Bent 36 Photo 1 of 2

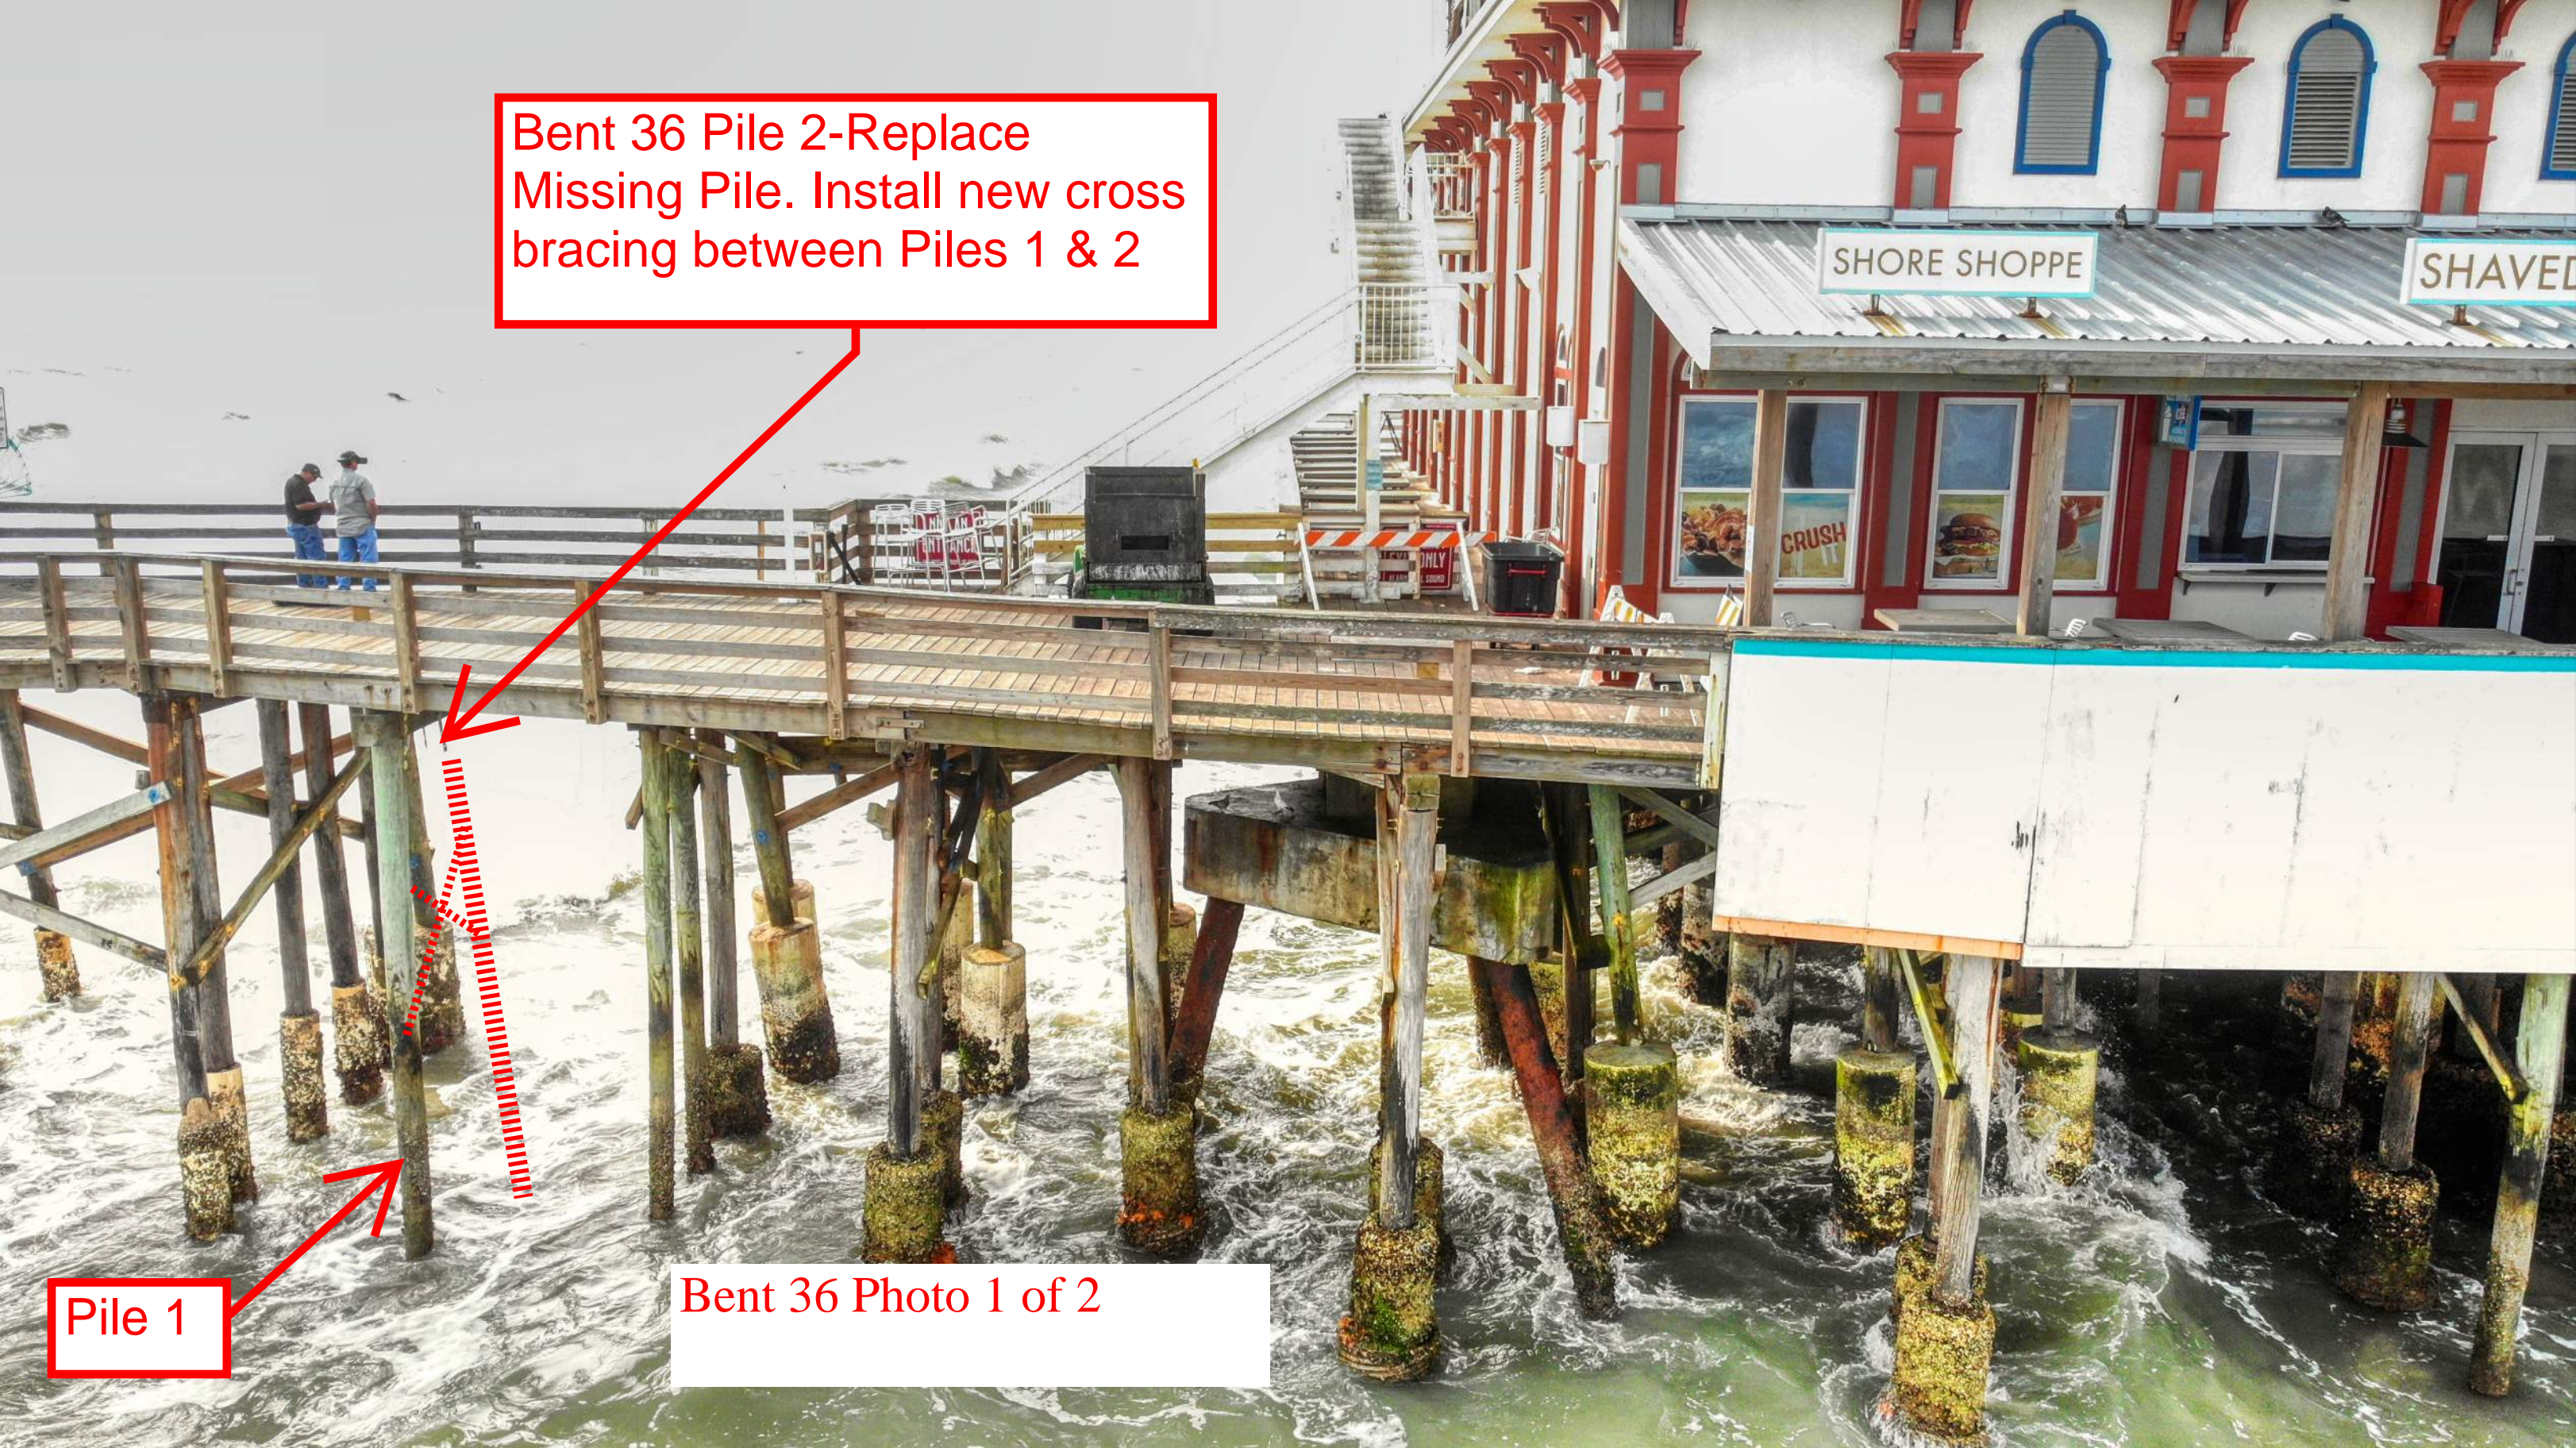
Bent 36 Pile 2-Replace
Missing Pile. Install new cross
bracing between Piles 1 & 2

Pile 1

Bent 36 Photo 2/2

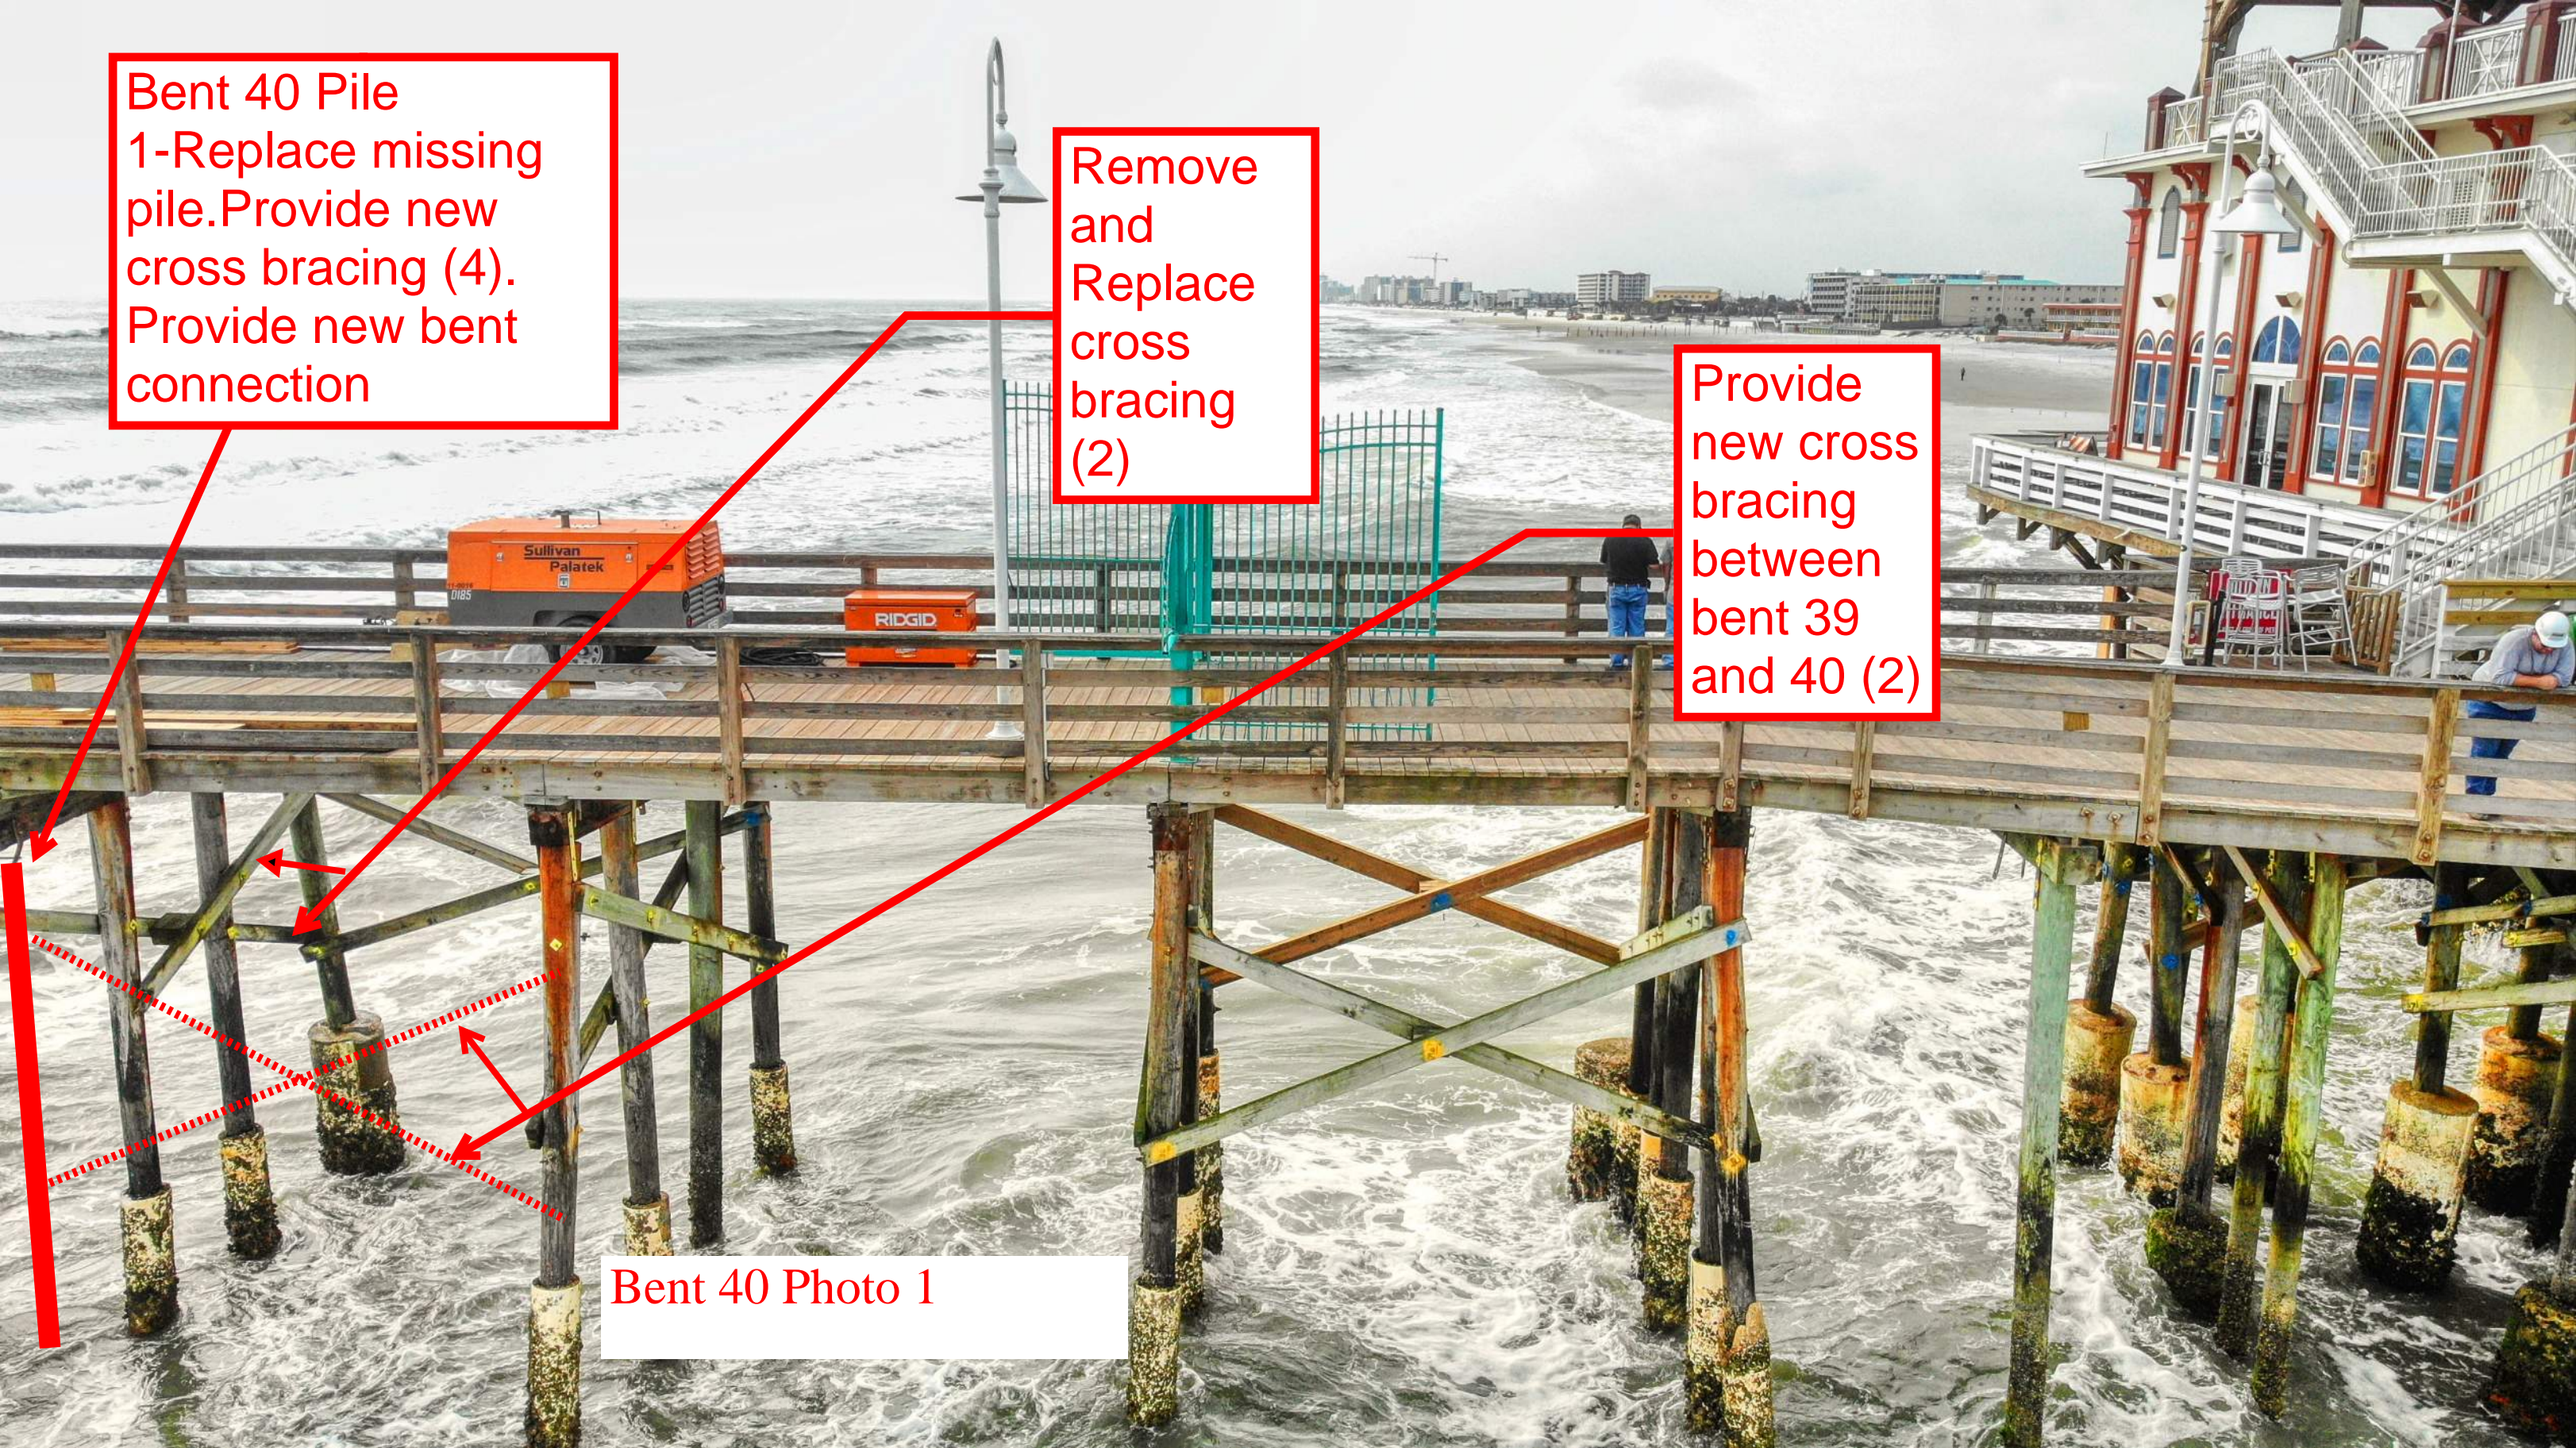
Pile stub
Bent 36
-pile #2
location

Bent 43
photo 2/2

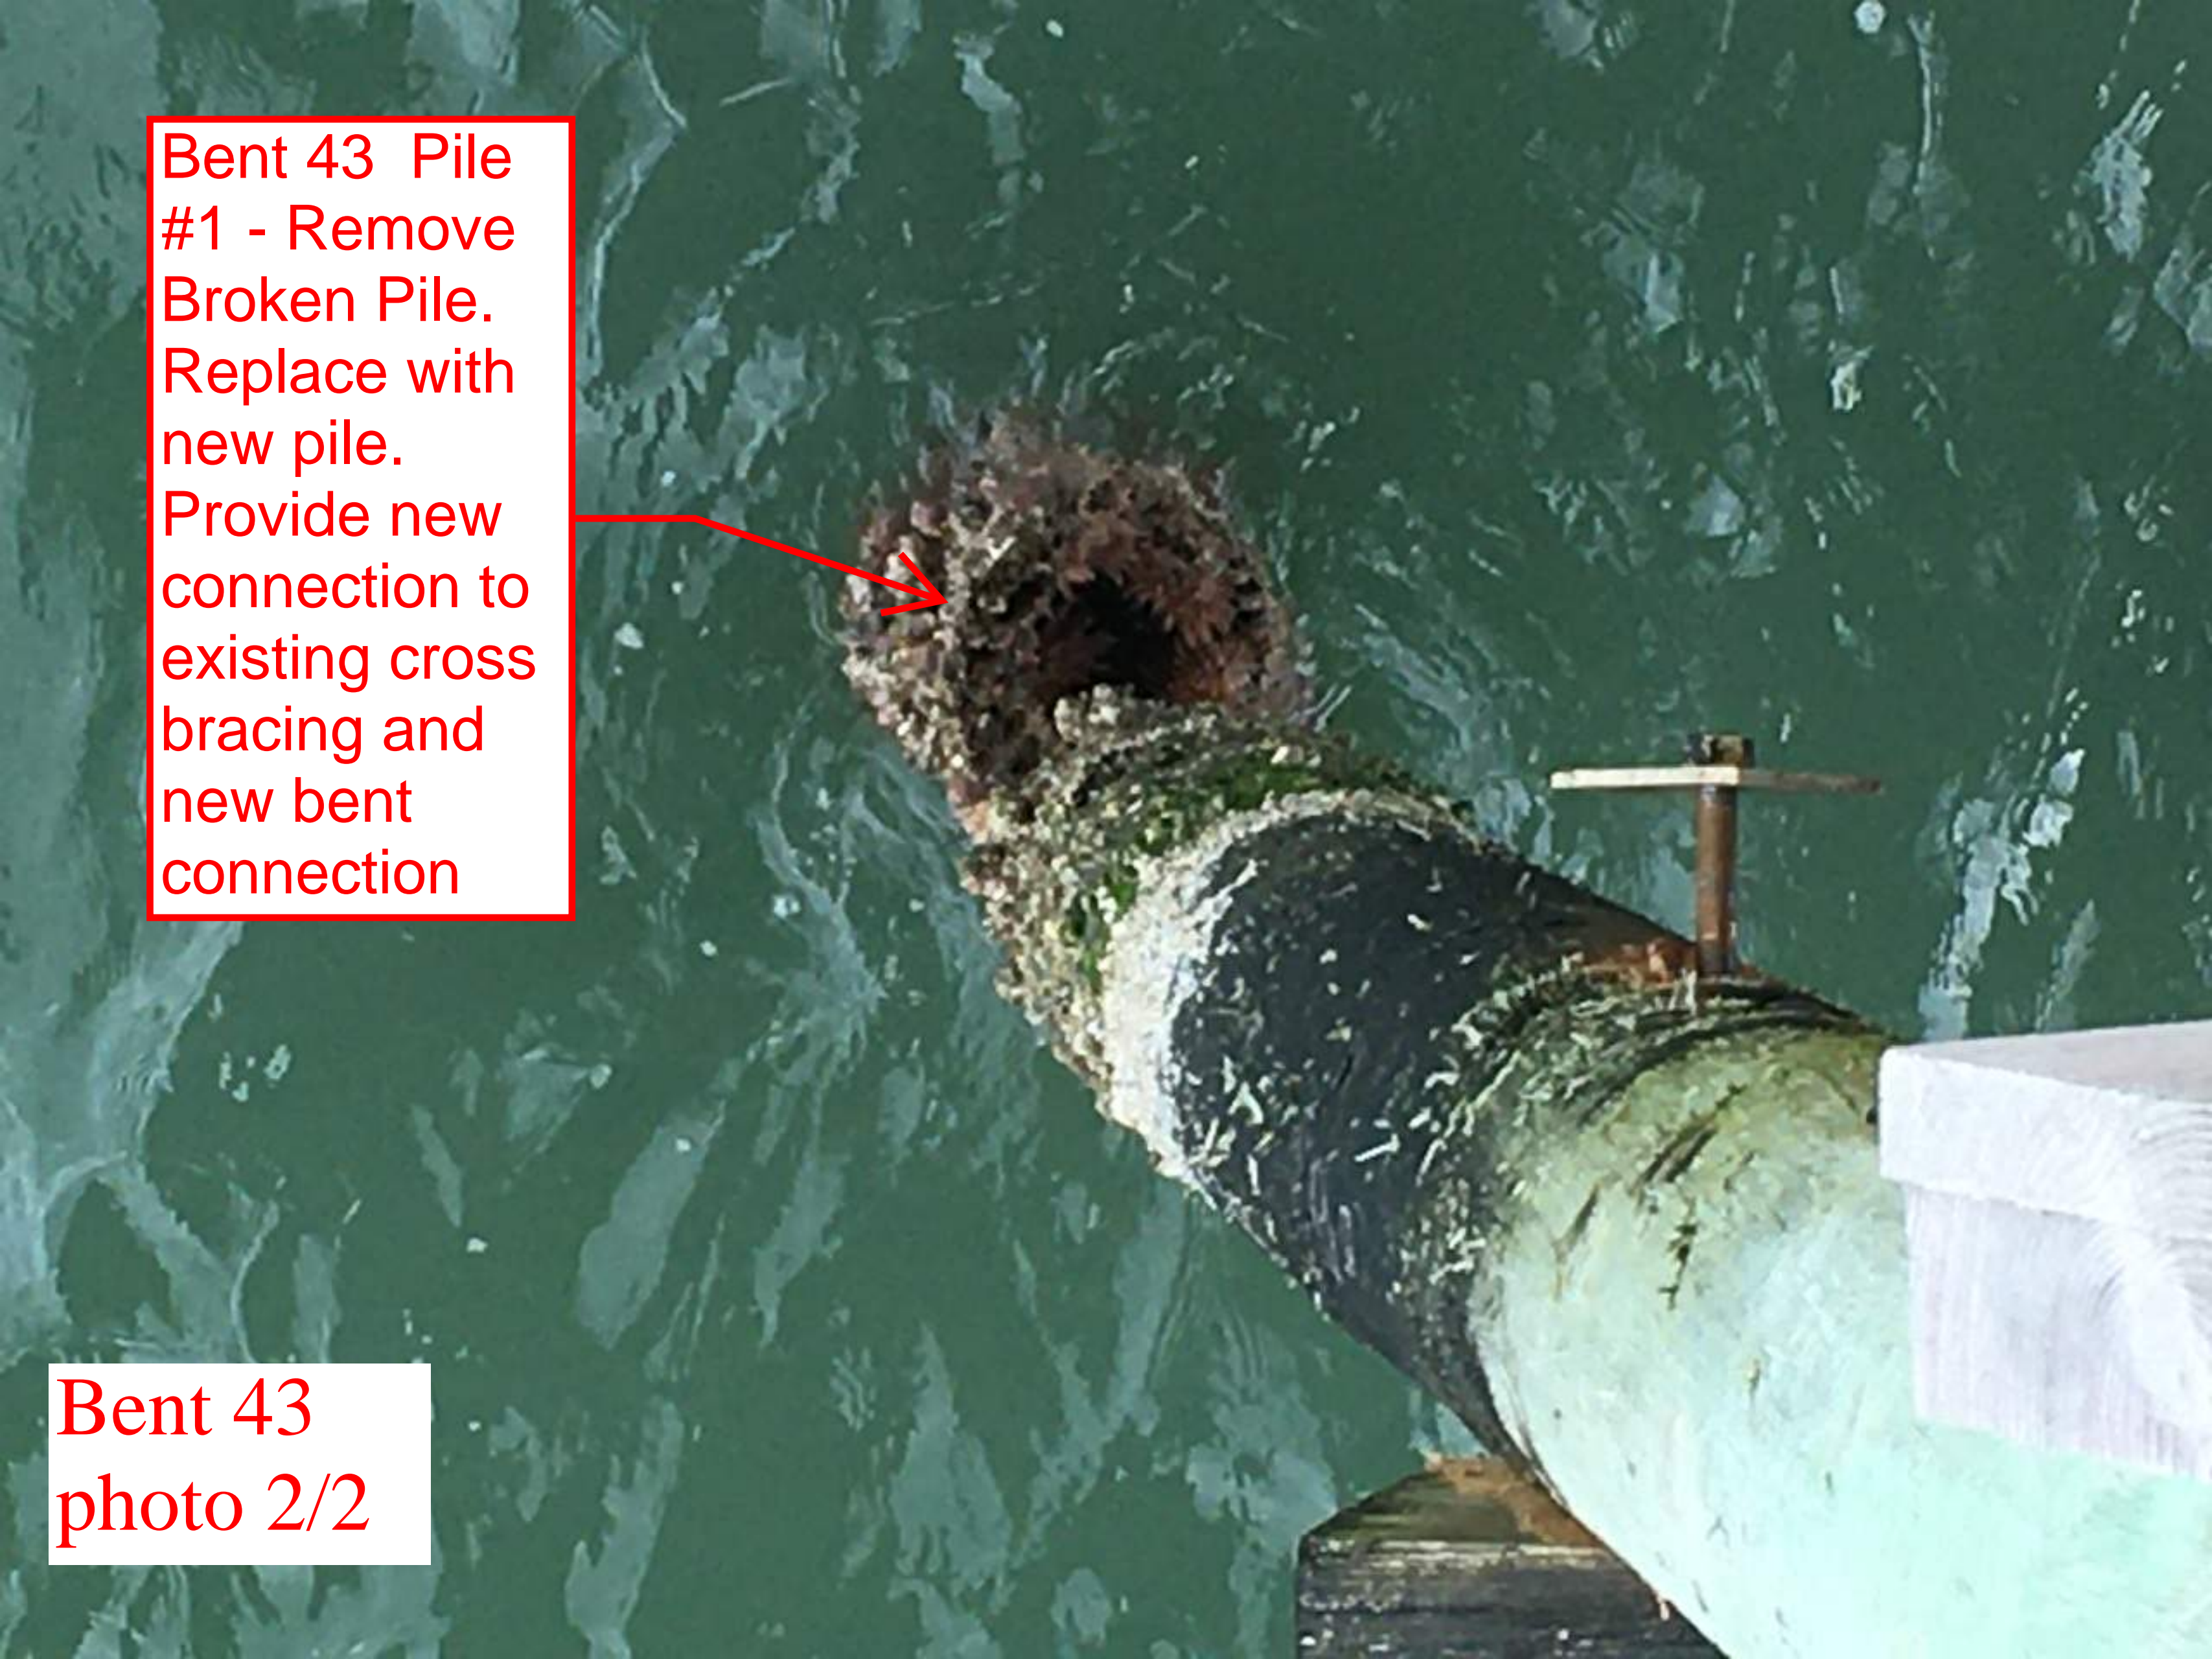
Bent 43 Pile
#1 - Remove
Broken Pile.
Replace with
new pile.
Provide new
connection to
existing cross
bracing and
new bent
connection
